No.	2021-P168
To	Board of Directors
Date	2021-04-22

Zibi Site – Developed Design of Terasini Park

2020-P168 - Zibi Site – Mokaham,
Pangishimo and Terasini Parks 66% Design
Development FLUDA (C)

Tesasini Park

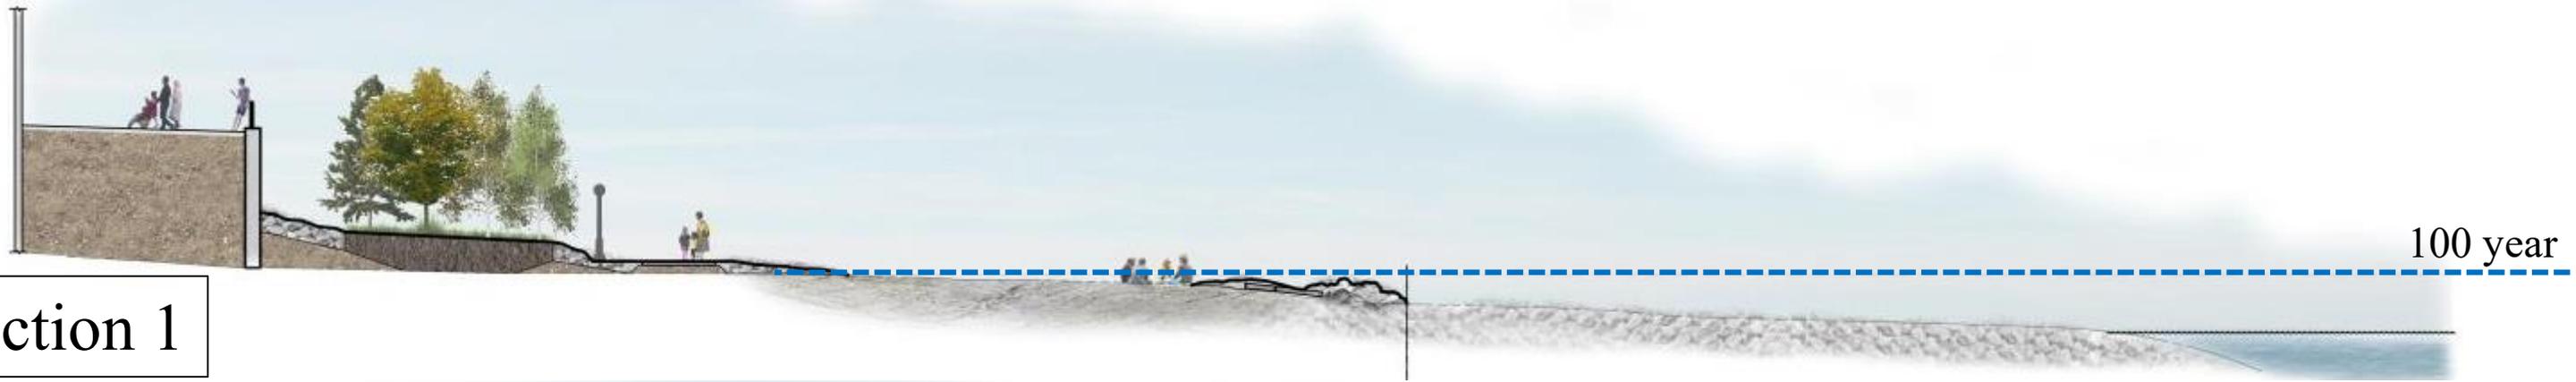
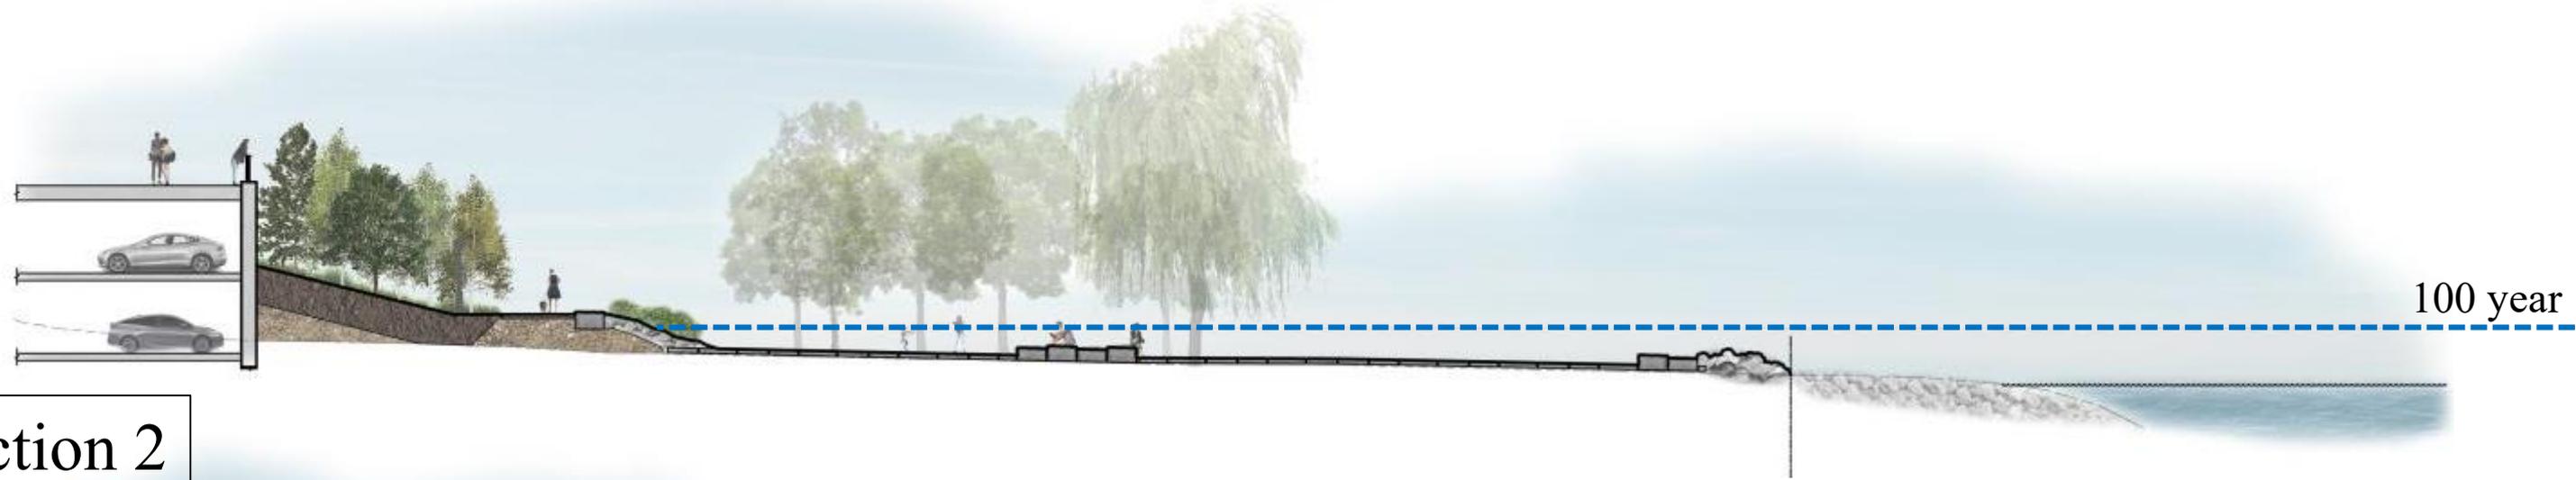
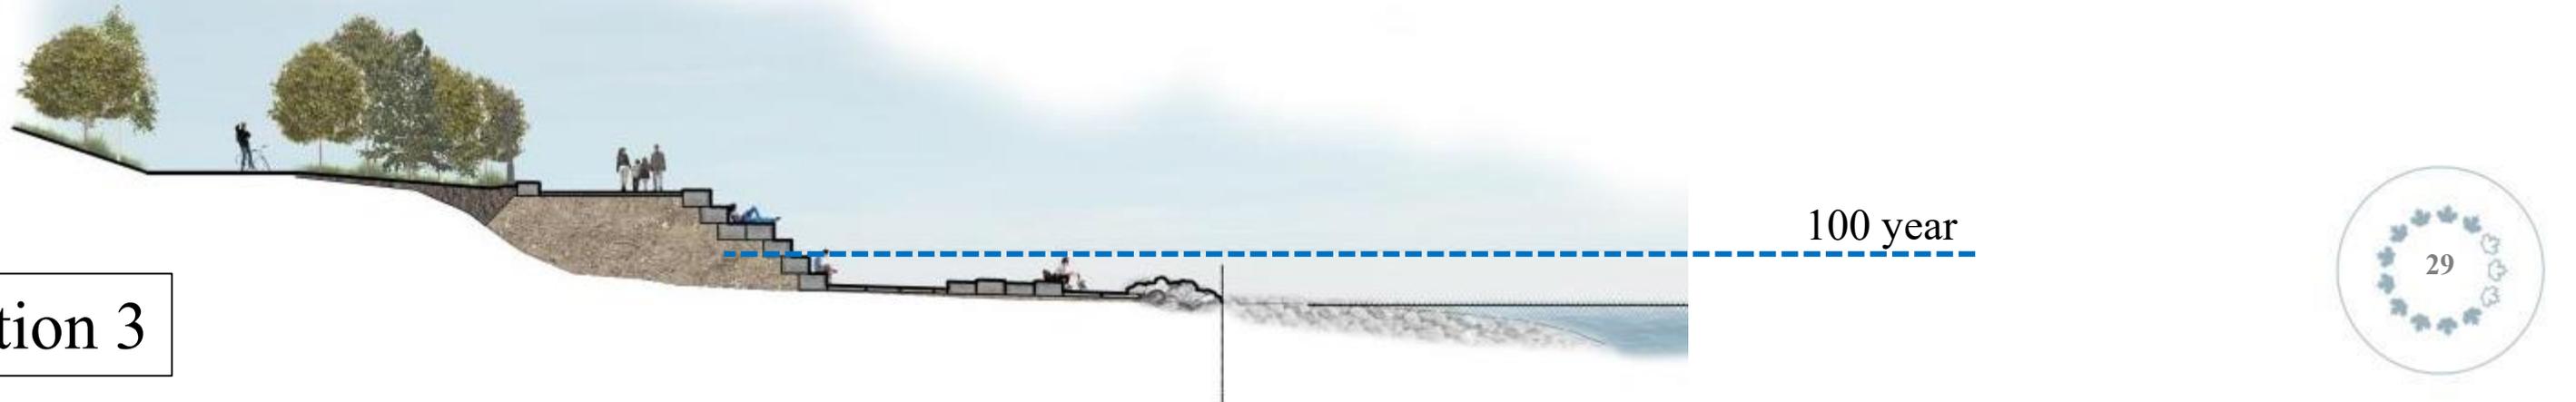
- The level of floods should be planned for a longer horizon than the 100-year mark for increased resiliency.
- When safe and possible, the water should be used as part of the solution.
- Maintaining existing trees will be challenging with flooding, rockfill, sediment deposition, planned excavations, etc.
- Existing trees should be protected from further damage from flooding as much as possible.

The majority of the area will feature only informal access when the water levels are low and includes a UA pathway above the 100-year flood plain with two lookout rest stops which will be accessible year-round. A belt of new native planting will be installed north of the pathway, providing a green buffer between the Zibi development and the shoreline.
